# MULLALOO BEACH IMPROVEMENT PLAN

MULLALOO BEACH PRECINCT  
SCHEDULE OF SUBMISSIONS FOLLOWING RE-ADVERTISING  
(CLOSED 10 MAY 2002)

PREFERRED BEACH PROMENADE  
PATH DESIGN

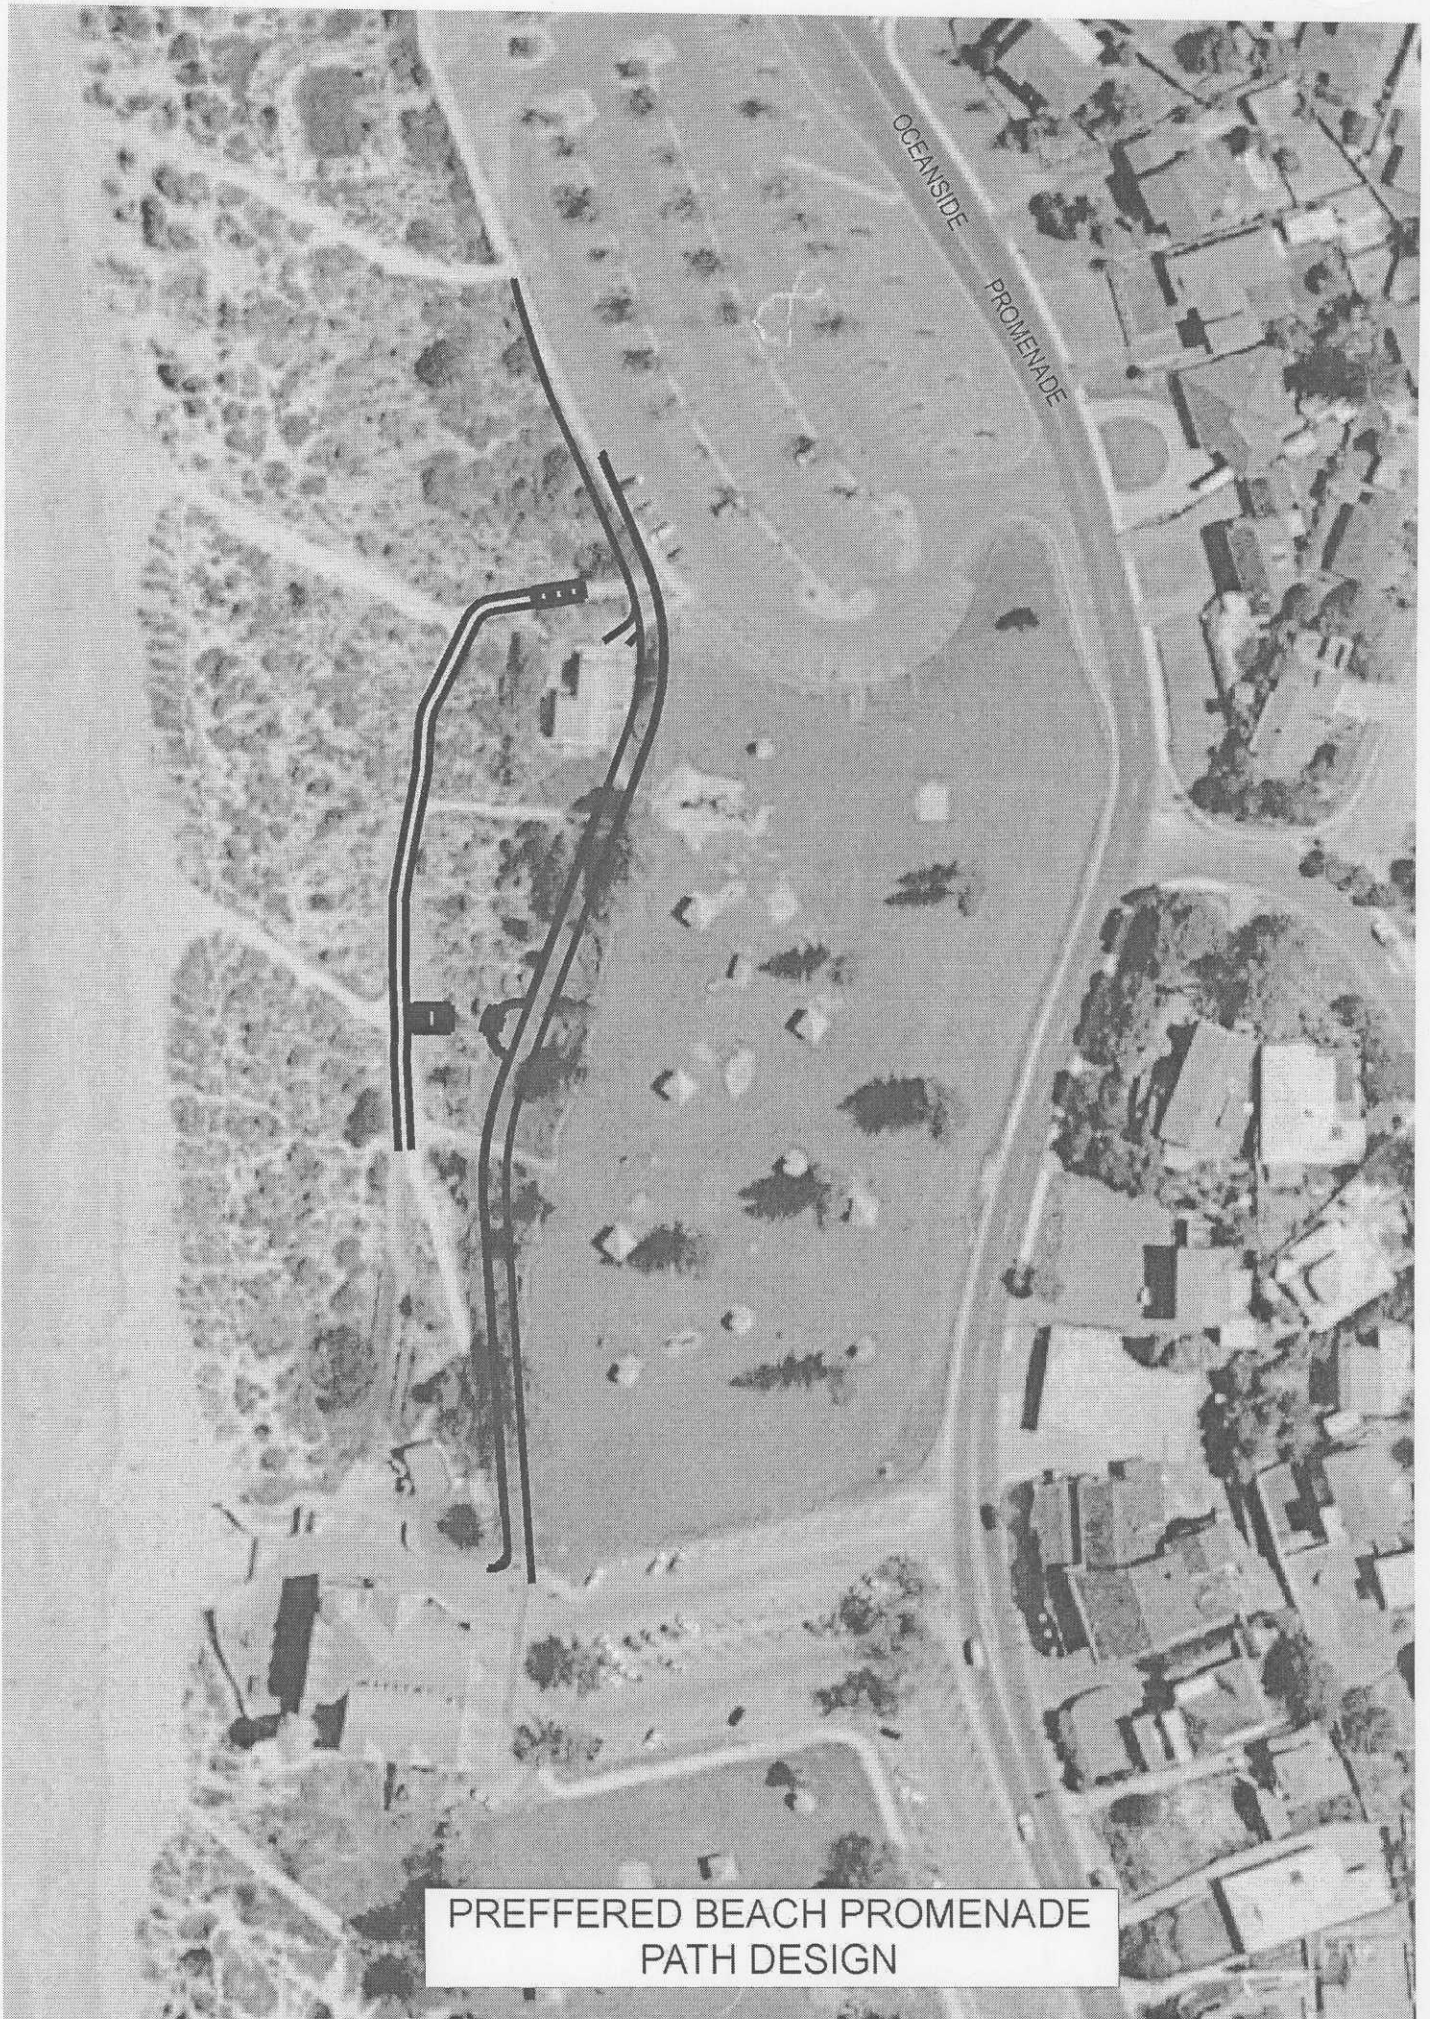
66	E and G Seifert 10 Galley Place Ocean Reef WA 6027	<p>Generally supportive and recognizes the need to reconcile different views. Comments offered to be constructive.</p> <p>Details</p> <ol style="list-style-type: none"> <li>1. Convert all of grassed area to Tom Simpson Park.</li> <li>2. Minimize changes to road alignment/intrusion into the park.</li> <li>3. How will local road only operate?</li> <li>4. What is strengthen median planting</li> <li>5. Prefer southern entry to northern carpark to stay open</li> <li>6. Further rationalize Northern carpark</li> <li>7. Widen dual use path at car park</li> <li>8. Do not lose grass to dual use path.</li> <li>9. Do not relocate shelters.</li> <li>10. Reduce Oceanside Promenade road widening by placing lighting from median to side of street.</li> <li>11. Avoid paved surface with cracks.</li> <li>12. Avoid bus stop taking up grassed area.</li> <li>13. Review walk way through dune south of surf club for erosion.</li> <li>14. Add barrier between park and road for child safety.</li> <li>15. Leave car park at surf club as is.</li> <li>16. Reduce right turns coming out of car parks.</li> <li>17. Other detailed recommendations.</li> </ol>	<p><i>Noted.</i></p> <p><i>Noted. Not a action forming part of this project.</i></p> <p><i>Noted. To be addressed during detailed design phase of the project.</i></p> <p><i>Options will be identified during the detailed design phase of the project.</i></p> <p><i>Means additional planting of vegetation.</i></p> <p><i>Noted. Entry to be closed.</i></p> <p><i>Noted. Rationalisation of car parking area not a design element on the advertised plan.</i></p> <p><i>Noted. The location of the path is upon unusable land. Refer to comment in body of the report.</i></p> <p><i>Noted. Some shelters will require relocation, however to be addressed during the detailed design phase of the project.</i></p> <p><i>The enhancements to the road are intended to be entirely accommodated within the existing road carriageway, not on grassed areas.</i></p> <p><i>Noted. To be addressed during the detailed design phase of the project.</i></p> <p><i>Noted. Refer above comment.</i></p> <p><i>Noted. No change to car park proposed, other than upgrading.</i></p> <p><i>Many of the remaining suggestions relate to detail design and may be considered if the plan progresses to the detailed design phase.</i></p>
